**DIRK & TAMI ELLIS**  
NATURAL FOOD STORE  
ROADRUNNER DRIVE ■ HELENA, MONTANA  
ENVIRONMENTAL RESPONSE RECOMMENDATIONS  
DECEMBER 10, 2003

**JAMES COOKE**  
302 12<sup>TH</sup> STREET SW  
ALBUQUERQUE, NEW MEXICO 87102  
505.301.8533

**SECTION I: PASSIVE GAIN AT SOUTH WALL**

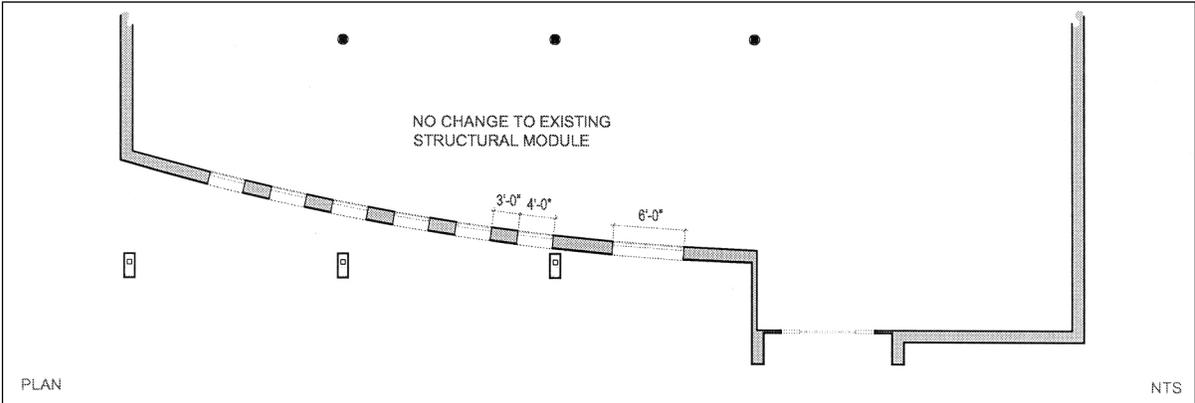
The recommended scheme increases total fenestration in the affected area of the south elevation by 65% (100 s.f. < 165 s.f.). As shown, 3 windows at south coffee shop booths are reduced to 4030 units to reduce glare. Heat loss from east facing windows far exceeds heat gain. If the total fenestration at the east elevation is reduced (especially at second floor Unfinished Storage) it is possible to affect total potential gain with less total building fenestration than originally proposed.

1. Design for 8 ea. 4030 double-glazed / high solar gain Low-E window units @ 6" AFF; nighttime screening to inhibit heat radiation to nighttime sky
2. 2 ea. 4030 double-glazed (high solar gain optional) site-line window units above 2 easternmost high gain units; sheer screening necessary October through February
3. Omit 3 clerestory 4020 window units; remaining 4 to be obscure glass for light diffusion
4. 6" sills to be precast concrete stained darker for immediate exterior gain and daytime conduction at exterior of gain windows; insulated from interior slab
5. Reduce fenestration @ south-facing Coffee Shop and east elevation; consider reducing 2 easternmost south-facing windows @ second floor Unfinished Storage; obscure (diffusing) glass @ all Unfinished Storage windows and @ clerestories other than Office

**SOLAR GAIN CALCULATION**

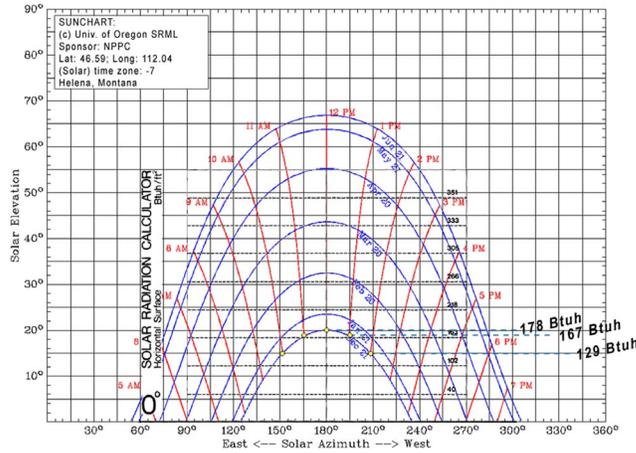
December 21 gain totals can be used to estimate worst-case heating requirements for the purposes of sizing Ground-Source Heat Pump equipment. Seasonal totals are shown to suggest the magnitude of annual energy savings. Gain is calculated for the windows indicated in the top right frame.

**SECTION II: GRID-TIED PHOTOVOLTAIC POWER GENERATION**

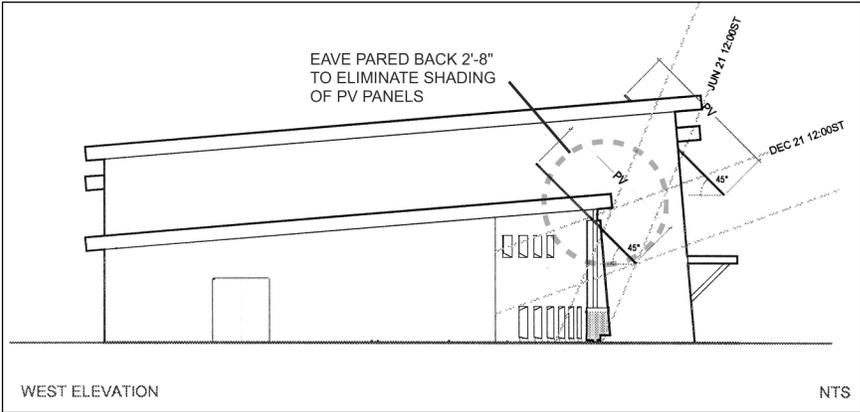
The application shown here represents the end result of several exercises exploring the possibilities for the maximum PV array possible given the lower sun angles at 46.6°N and the architecture as designed. Although it does not exhaust the total potential, it does maximize power generation as an *integrated* component and derives secondary value as awnings for pedestrian ways and second story south-facing windows.

1. Design for a minimum 12.5 kW grid-tied photovoltaic array (78 BP Solar BP 3160 panels)

#### SECTION IV: RAIN HARVEST

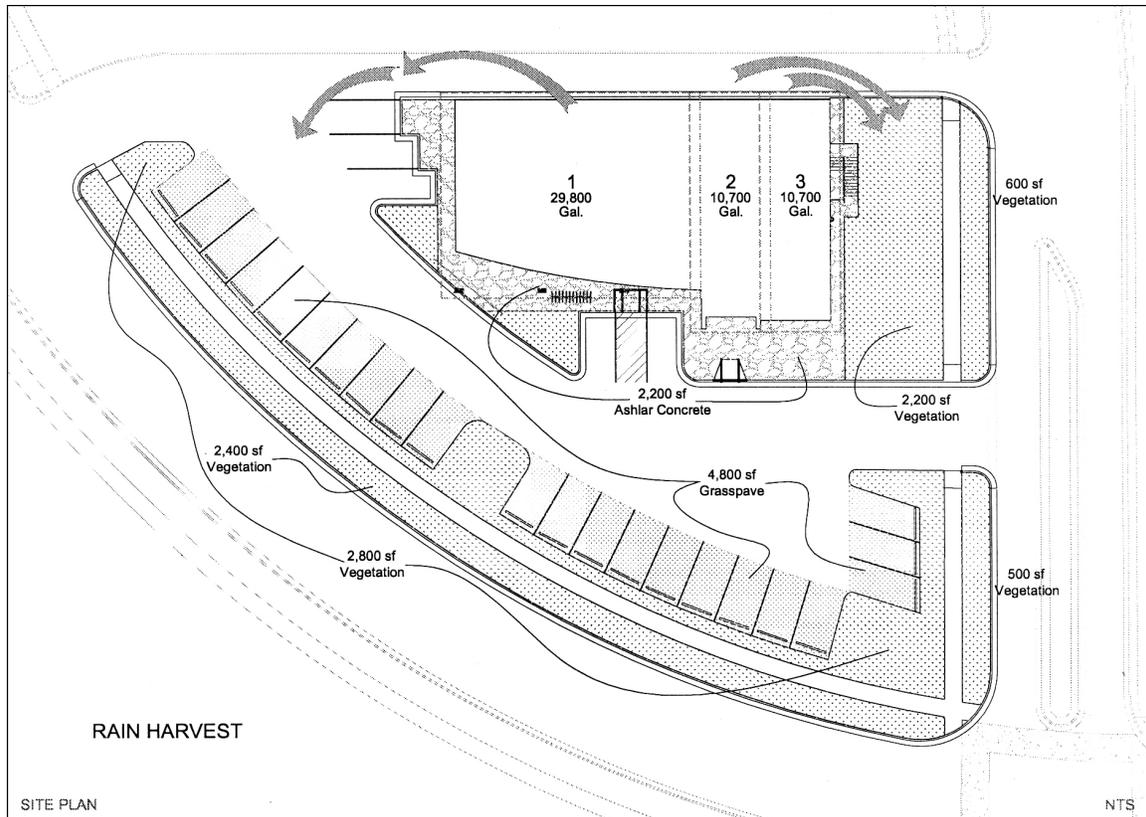
As shown in the line drawing, the permeable customer parking displaces 27% of site paving. The 2,200 square feet of permeable patio reduces site total paving to 10,775 square feet — an area roughly equivalent to the 9,000 square feet planted. The permeable surfaces (and the vegetation they support) will also significantly reduce the Heat Island affect on site and at building perimeter resulting in increased comfort and decreased energy requirements for cooling.

1. 4,800 sf of Grasspave<sup>2</sup> @ peripheral customer parking graded to planted areas
2. 2,200 sf of Ashlar (recycled) concrete (probably available from Helena City Maintenance at little, or no, cost) in place of monolithic concrete patios
3. Roof runoff directed to planted areas as indicated
4. Stormwater retention basins remain but graded to retain major events at no reduction to sheeting flows
